**Re: The Boeing Company**  
**IBFS File No. SAT-LOA-20170301-00028**  
**Call Sign S2993**

On behalf of The Boeing Company (“Boeing”), please find attached a corrected copy of our response to the questions raised in your letter dated June 22, 2017.<sup>1</sup> This version corrects the description of a line item in the link budget in Figure 2 in our response to question 9. The line item currently reads “Expected PFD at adjacent GEO (single XL)” and should read “Expected PFD at adjacent GEO (12 sources).”

Figure 1 – LEO to Ka-band GSO Relay and Ka-band GSO "Victim" Satellite Scenario

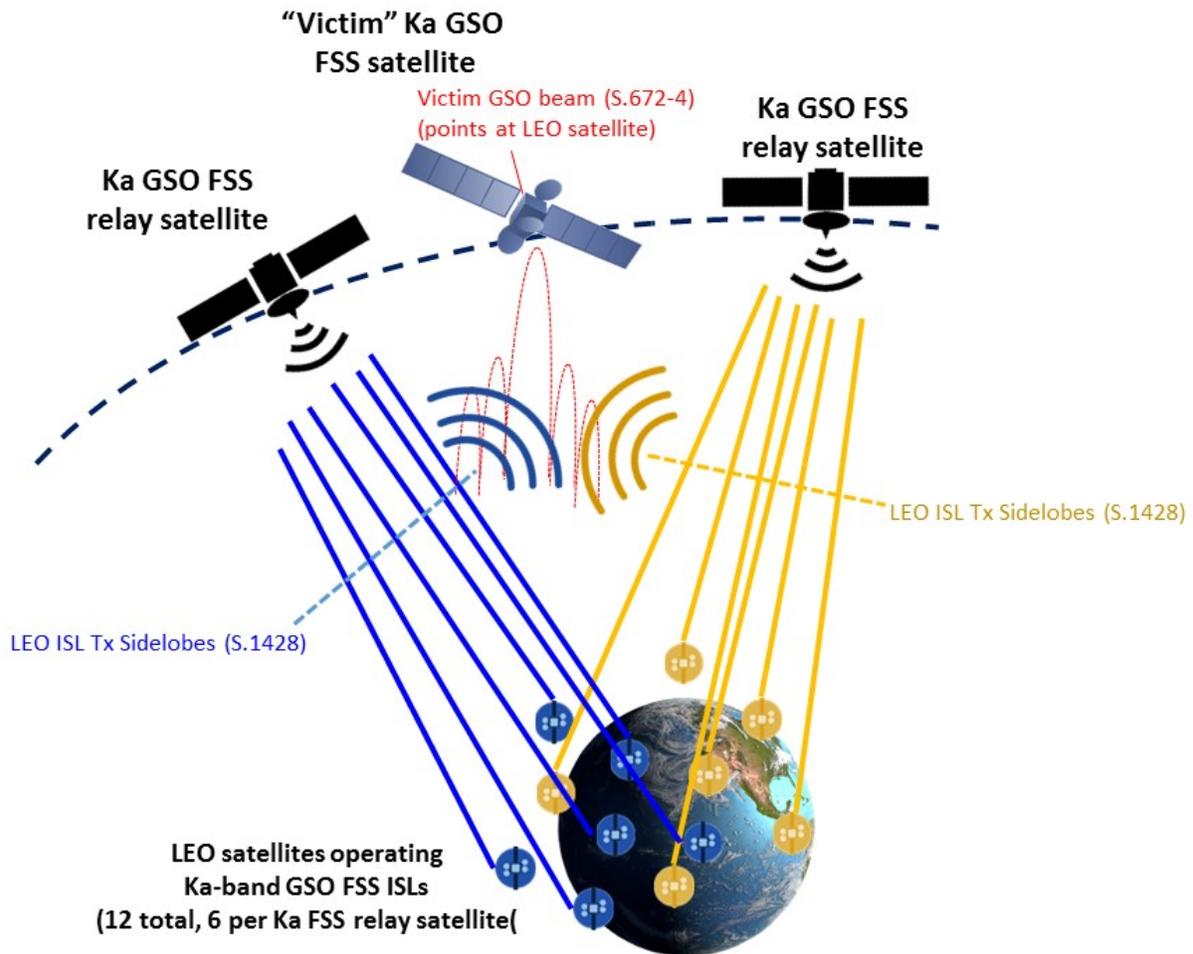
9. *Article 22 of the ITU Radio Regulations specifies equivalent power flux-density (epfd) limits that are applicable in several frequency bands in which Boeing proposes to operate. These include  $epfd_{up}$  limits in the 27.5-28.6 GHz and 29.5-30 GHz bands. Please provide a showing demonstrating the Boeing satellite system's compliance with the applicable epfd limits specified in Article 22 of the ITU Radio Regulations in these frequency bands.*

Currently, there is no approved ITU software that can compute an EPFDup level with sources operating on LEO satellites. Nevertheless, Boeing has computed the EPFDup generated by its proposed Ka-band ISL operations in a scenario that reflects heavy usage of Ka-band ISLs by Boeing's LEO constellation. The specific scenario, shown in Figure 1, assumes a total of twelve LEO satellites using ISLs to transmit to two relay satellites in geostationary orbit ("GSO"), which are each spaced at two degrees east and west of a separate Ka-band GSO satellite, which represents the "victim" Ka-band GSO satellite experiencing interference from the

Boeing ISL operations. Six LEO satellites are communicating with each GSO relay satellite and are operating a maximum uplink PFD level consistent with the EIRP density in the Boeing application and taking into account free-space path loss to the GSO satellite(s). The Boeing LEO satellite ISL beam patterns are consistent with a 1.2 degree beamwidth and use the ITU-R S.1428 beam patterns (for earth stations), while the victim GSO satellite beam is consistent with the 1.55 degree ITU-R S.672-4 beam pattern specified in the ITU Radio Regulations for EPFDup computations. The victim GSO beam is pointed at the worst-case location, which is directly overlapping one of the LEO satellite(s). Figure 2 below illustrates the results of the EPFDup modeling over the LEO constellation orbit variations.
